Product Change Notice (PCN)

PCN Number: PCN-0451070R-02

Product(s) Affected: PJ-028-SMT-TR

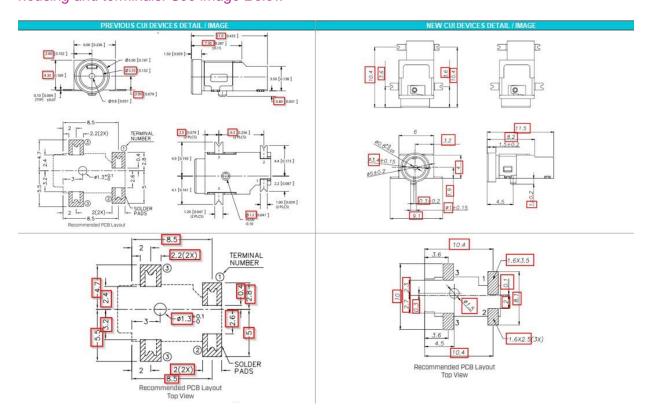
Description of Change: Minor Housing and footprint differences. Material Change on the housing and terminals. See image Below

MATERIAL	PLATING
center pin	brass	silver
terminal 1	brass	silver
terminal 2	copper alloy	silver
terminal 3	copper alloy	silver
plastic	PATOT

DESCRIPTION	MATERIAL	PLATING/COLOR
center pin	brass	gold
terminal 1	brass t=0.20	gold
terminal 2	phosphor bronze t=0.25	gold
terminal 3	phosphor bronze t=0.20	gold
housing	PA9T [UL94V-0]	black
